Re: Bursham Hall, Garage Conversion to Dining Facility – Stage 2 Structural Report.

STRUCTURAL COMMENTS / RECOMMENDATIONS
FOLLOWING SITE SURVEY ON 16/10/19.

PREPARED BY - CHAS MARWARD
F.G. MARWARD ASSOC LTD.
DRAWING N° SK1.
DATE - 29/10/19.

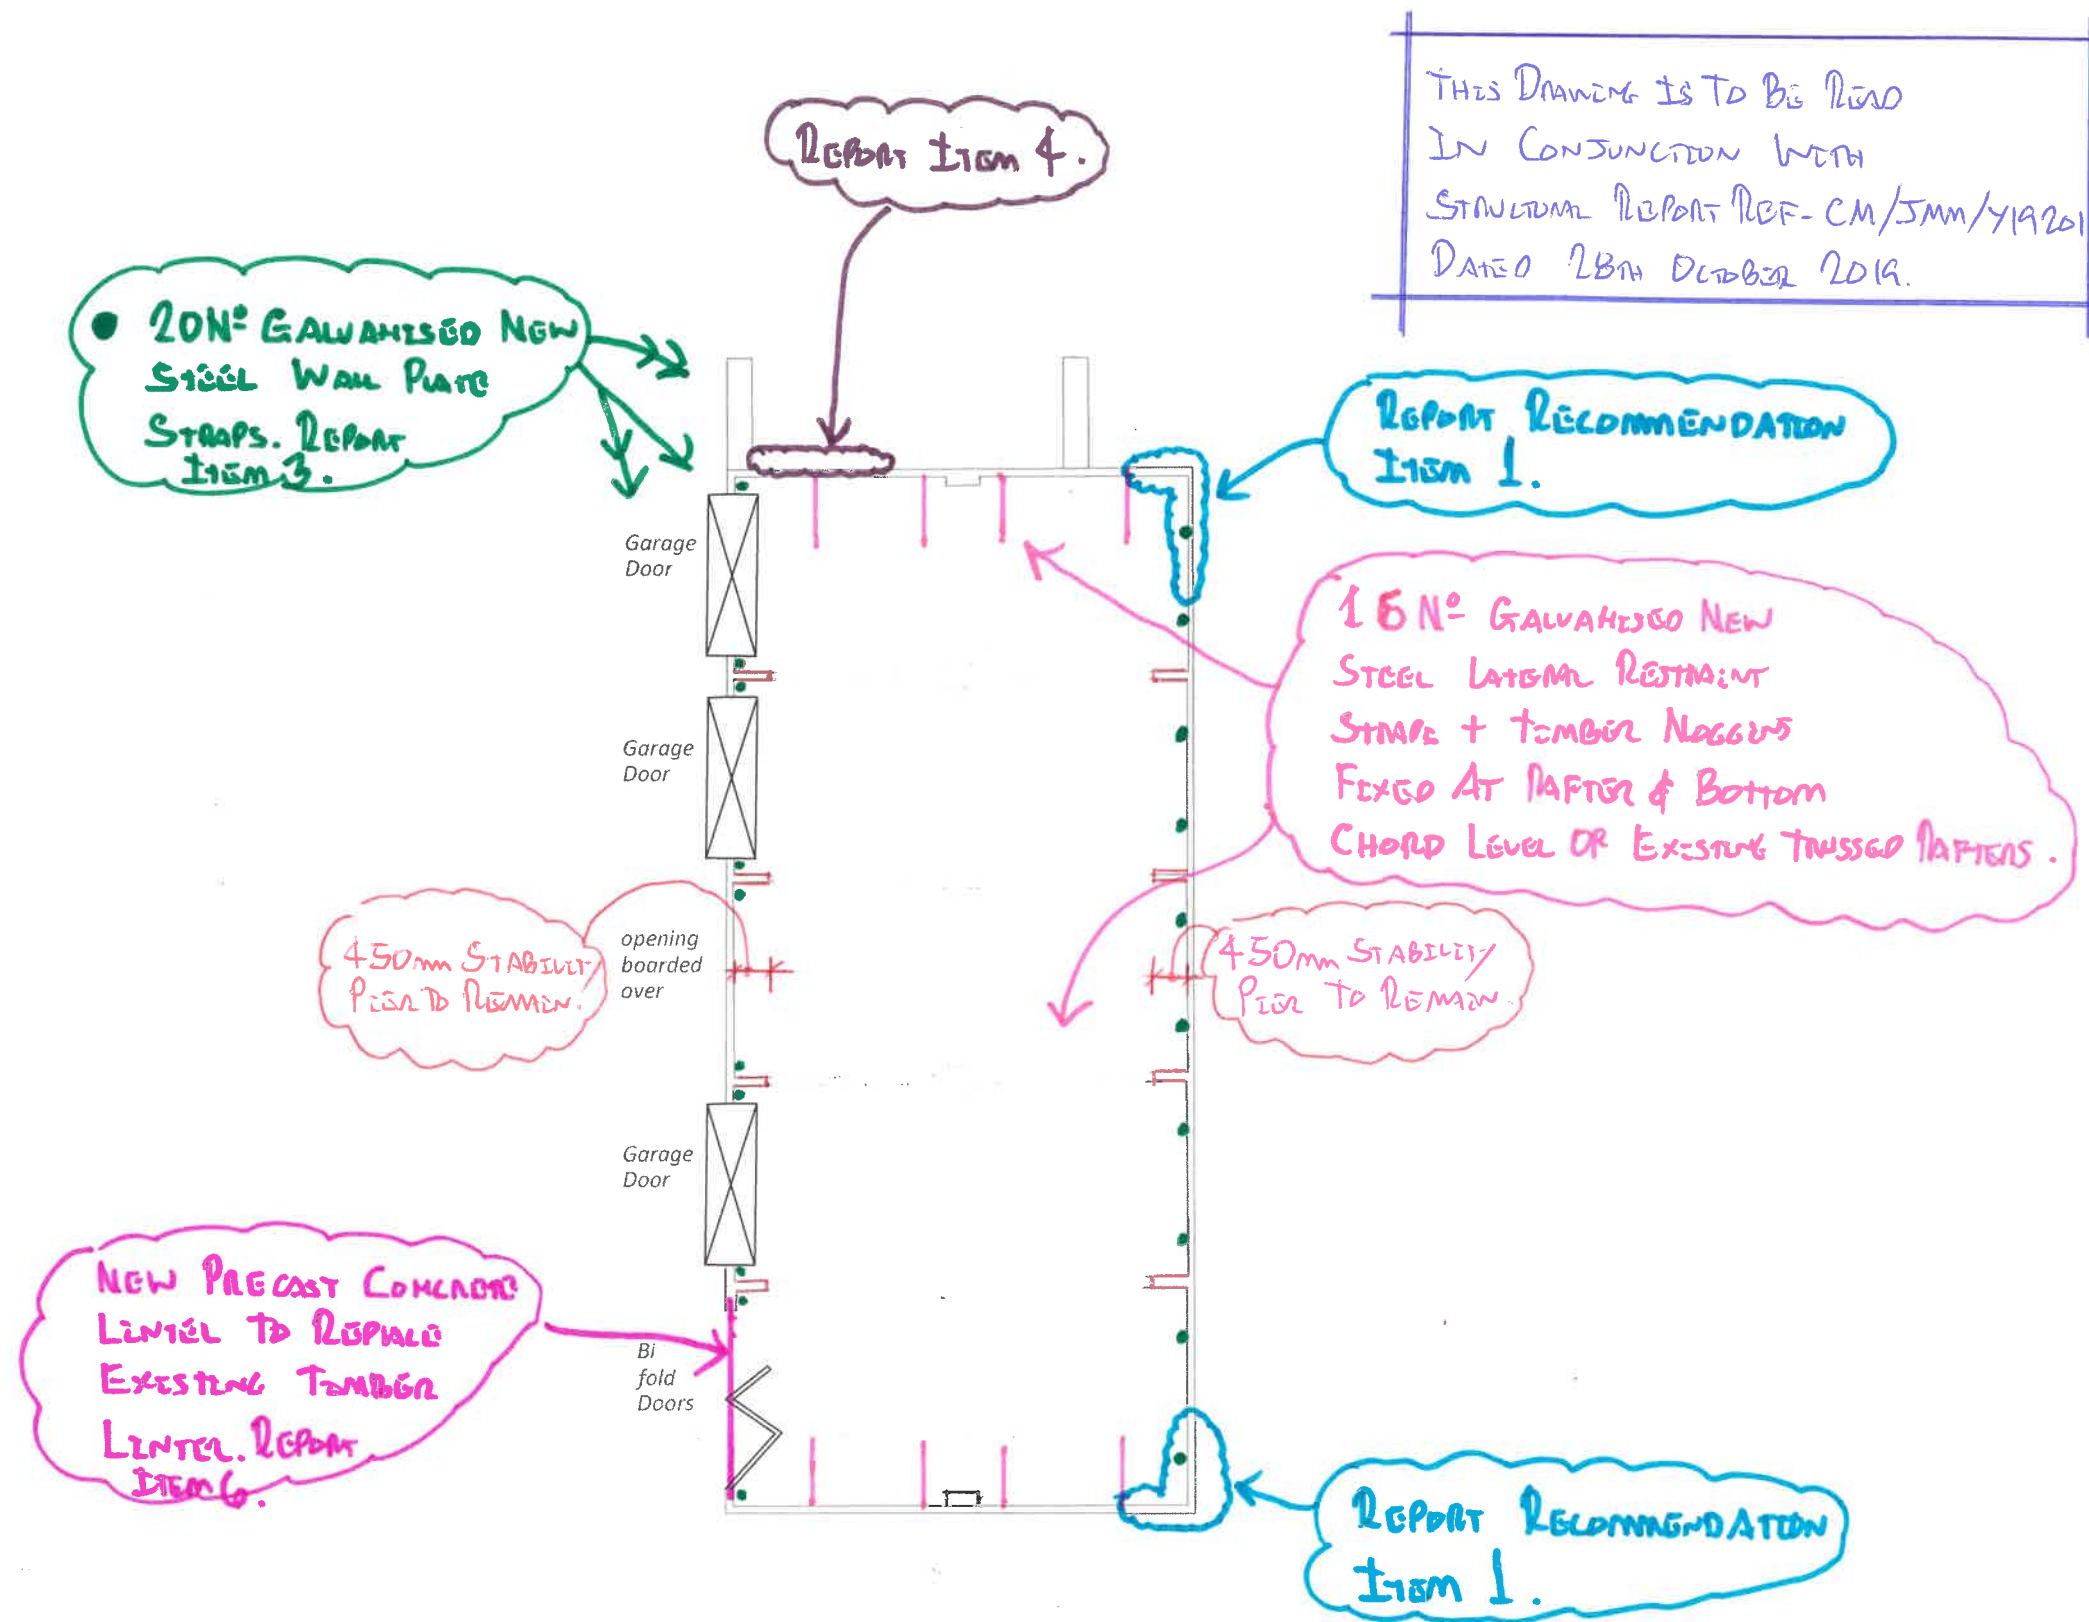
The internal inspection revealed signs of low level distortion and water ingress through the rear wall within the extreme left hand garage. The facing brickwork had clearly moved laterally at this location by a significant amount as a result of the root pressure from an external mature tree which was located within a few hundred millimetres from the rear corner of the building.

The existing timber wall plate to the front and rear elevation had not been adequately strapped down and was at risk of wind uplift.

The timber lintel to the folding sliding door to the extreme right hand garage was not considered to be structurally adequate to support the loading from the timber trussed rafters.

There were a number of mature trees located very close to the rear elevation. These trees were considered to be within influencing distance of the garage structure. There were signs of brickwork cracks within both rear corners of the external walls to the garage building which we consider are as a result of tree influence.

Inspection along the left hand gable wall revealed signs of salt attack to the facing bricks and mortar joints at low level. We suspect that road de-icing salts have been stored and stacked against this wall in the past, resulting in perished and re-cressed mortar joints along with minor damage to the brick faces.

1. Carry out localised rebuilding works to the cracked and laterally distorted facing brickwork to the rear elevation and rear corner locations.
2. Arrange for removal of all mature trees adjacent to the rear elevation.

3. Install galvanised steel wall plate straps to the front and rear elevations.
4. Undertake repointing works and brick repairs to the left hand side elevation at low level where salt damage has occurred.

5. Reduce the external ground levels to the rear and side elevations to prevent ground water seepage through the external walls.
6. Replace the existing timber lintel to the extreme right hand garage door opening with a precast concrete lintel.

7. Replace, clear defective/blocked gutters.
8. Unblock existing surface water gullies at downspout locations.
9. Re-route rear downspouts to discharge in to existing front gullies.

10. Undertake repairs to all holes within the existing pitched roof.
